ECE/TRANS/WP.29/GRSG/2010/8  
22 February 2010

**REGULATION No. 116**  
(Protection of motor vehicles against unauthorized use)

Revised proposal for draft amendments to Regulation No. 116

Submitted by the expert from Japan \*/

Paragraph 6.4.2.1.

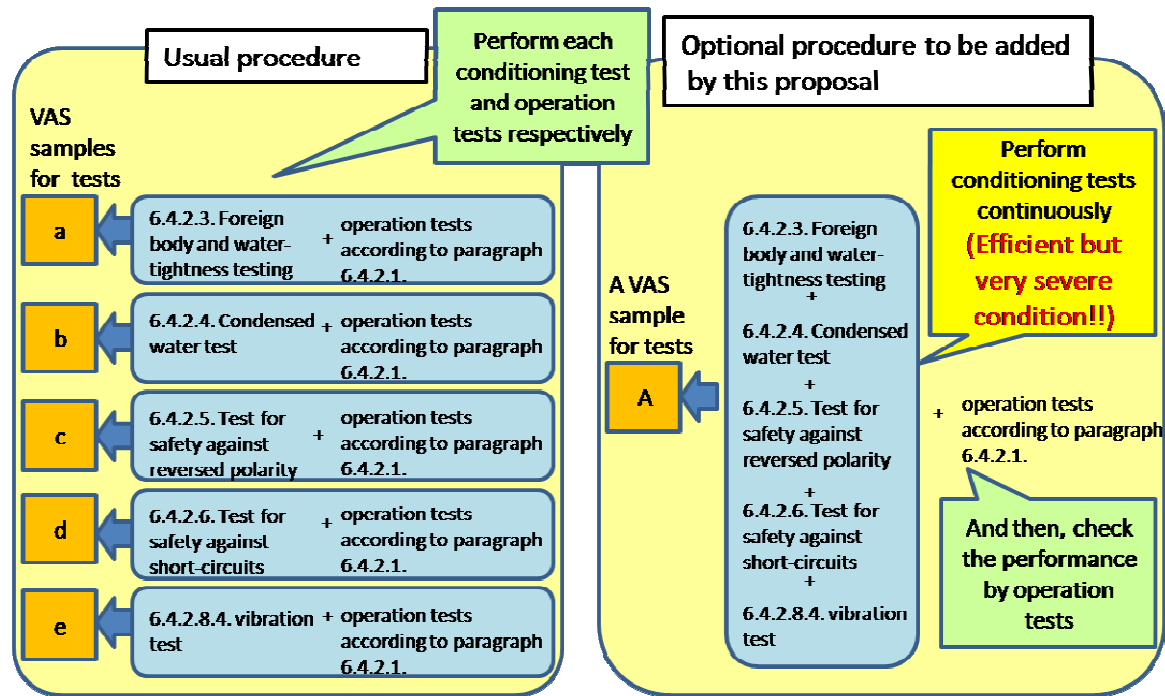
This proposal is to add an optional procedure to streamline the operation tests repeatedly required in paragraphs 6.4.2.3., 6.4.2.4., 6.4.2.5., 6.4.2.6. and 6.4.2.8.4. by adopting more rigorous conditions.

Performing some of the tests required in these paragraphs prior to the operation tests in series for a sample is more rigorous than performing one of these tests before performing the operation test with regard to test conditions.

This amendment enables exemption of the tests for a VAS approved as separate technical unit or an AS to be installed to the vehicle which is type approved. It is possible to apply vehicle type approval of the immobilizers and alarm systems without the type approval for components/separate technical unit, while some devices to prevent unauthorized use are not subject to such component type approval.

**For the operation tests required according to paragraphs 6.4.2.3., 6.4.2.4., 6.4.2.5., 6.4.2.6. and 6.4.2.8.4., if some of the tests required in each of these paragraphs prior to the operation tests are performed in series on a single VAS, the operation test may be carried out one time only after the chosen tests are completed instead of performing the operation tests required in the paragraphs after each of the chosen tests. Vehicle manufacturers and suppliers have to guarantee satisfactory results only on non accumulated procedures"**
